TSB082715

TECHNICAL SERVICE BULLETIN

SUBJECT: Redesigned Cutter Head Belt Tensioner

Models: All Magnum Harvesters Equipped With Timed Cutter Heads

Figure 1—The R-27 tensioner pulley has been replaced by the P2B pulley.

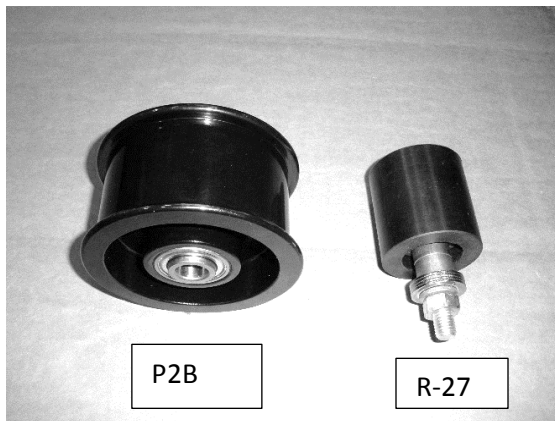
The belt tensioner pulley for the left cutter head has been superseded by a new improved design tensioner pulley. See **Figure 1**.

If the belt tensioner pulley replacement is necessary, call Bucyrus Equipment Company

at 800-330-0857 and request pulley part No. P2B.

Figure 2—Use the provided washers to center the pulley under the belt.

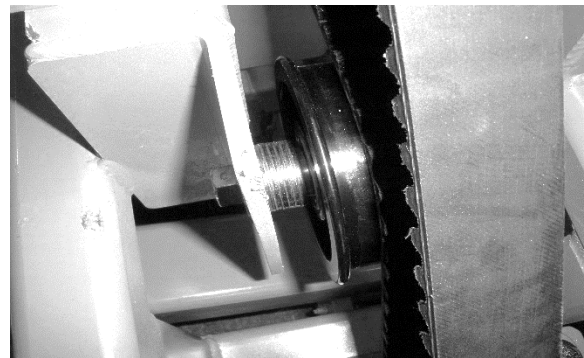
1. Remove and discard the original tensioner pulley (R-27).
2. Determine the appropriate number of washers to install on either side of the pulley to center the pulley on the head drive belt. See **Figure 2**.

Figure 3—View showing the tensioner pulley properly installed.

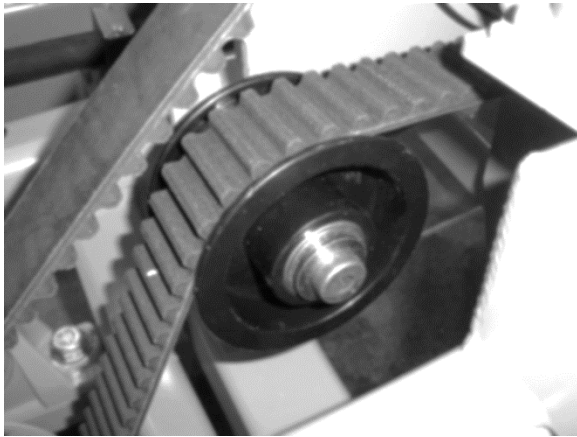
3. Attach the new pulley (P2B) to the mounting bracket using the provided fastener. See **Figure 3**.
